Town of Arlington, MA Redevelopment Board

Agenda & Meeting Notice March 28, 2022

9:15 p.m. Docket #3690, 34 Dudley Street

Department of Planning & Community Development 730 Massachusetts Avenue, Arlington, Massachusetts 02476

A-106

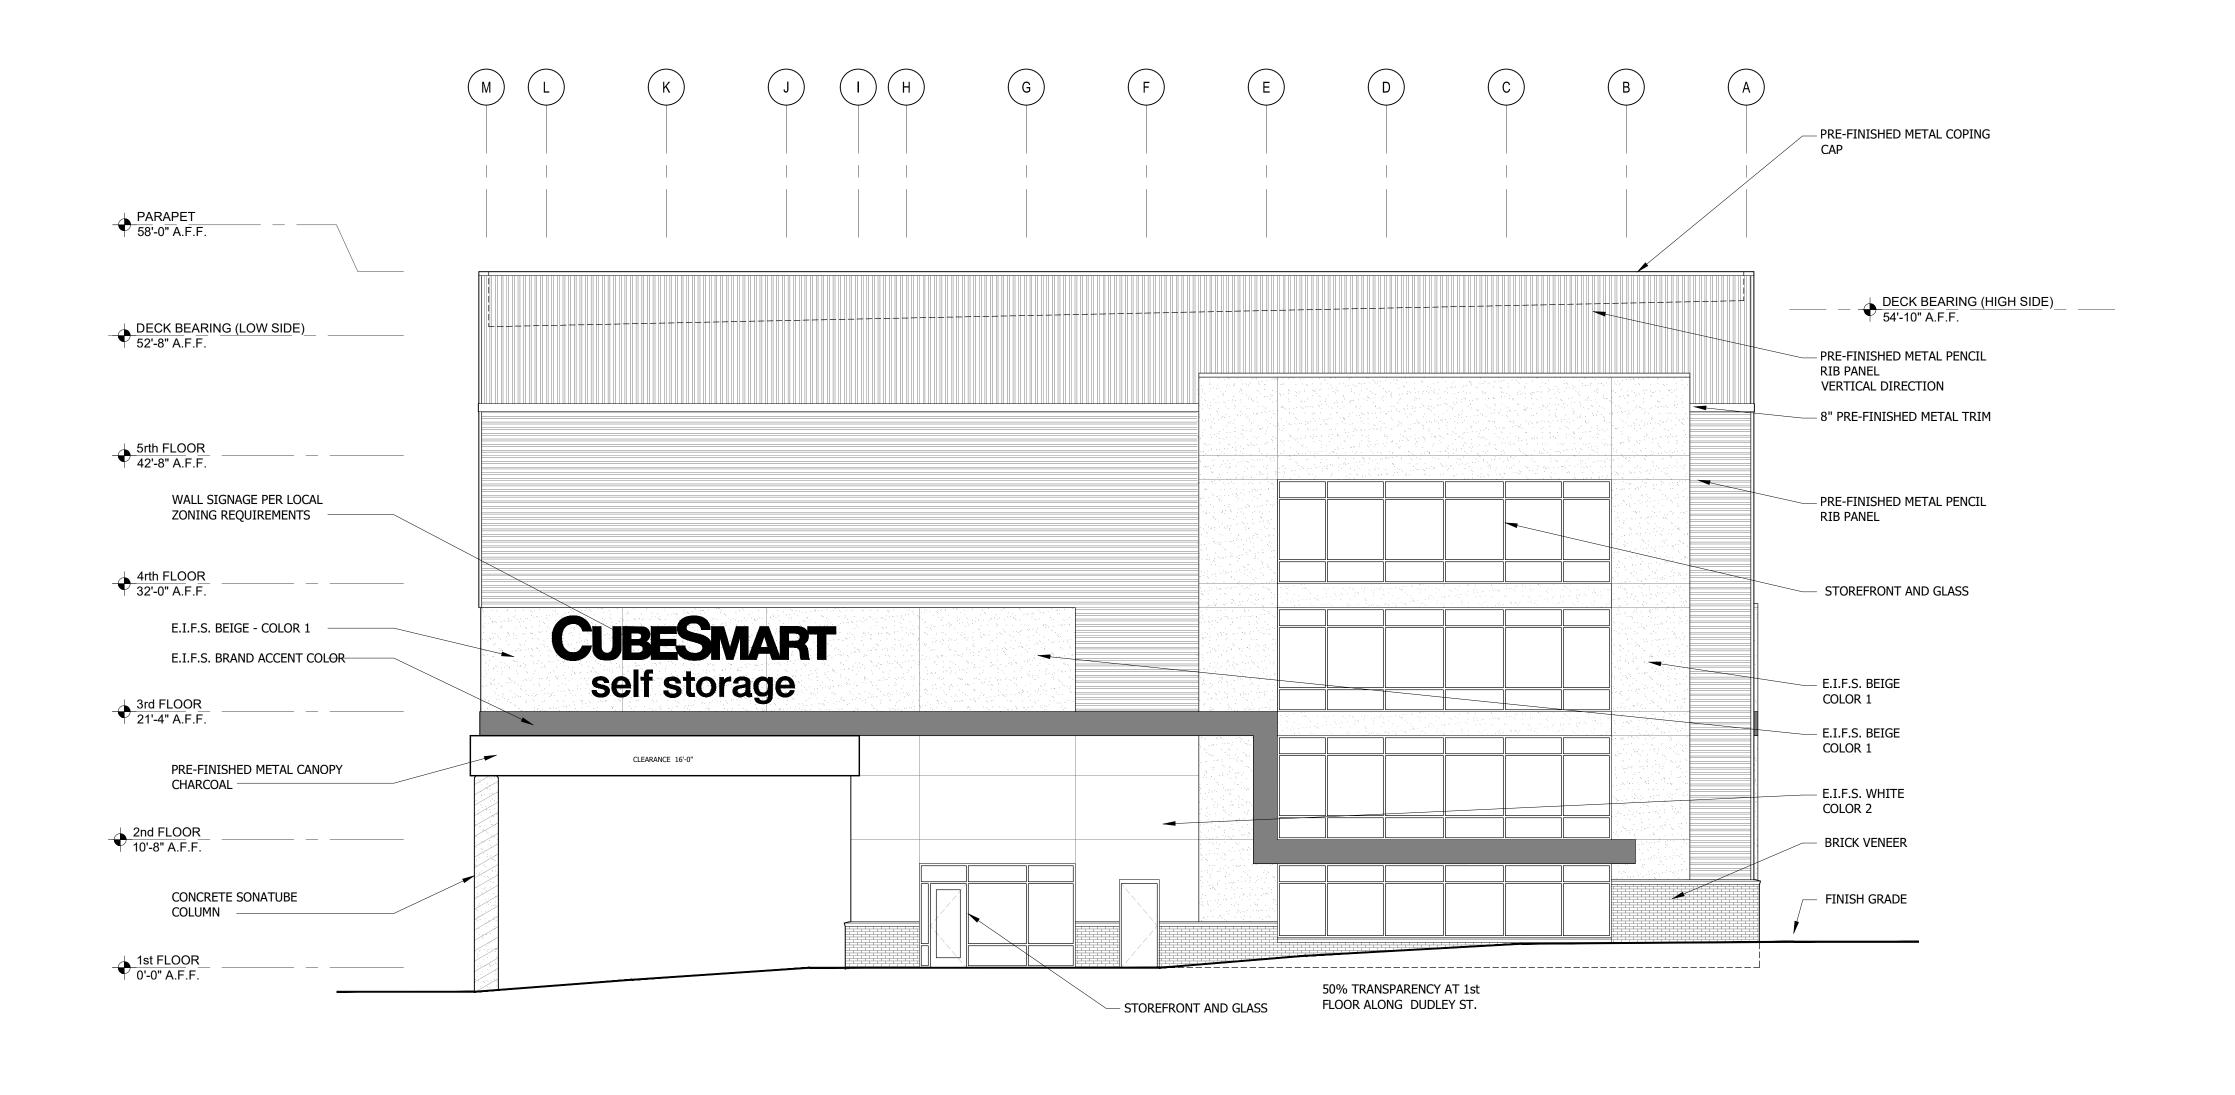
- Renewable Energy Installations: As shown on Sheet A-106, the roof structure will be solar ready, and will be coated with a white roofing membrane to reduce energy and reduce heat buildup.
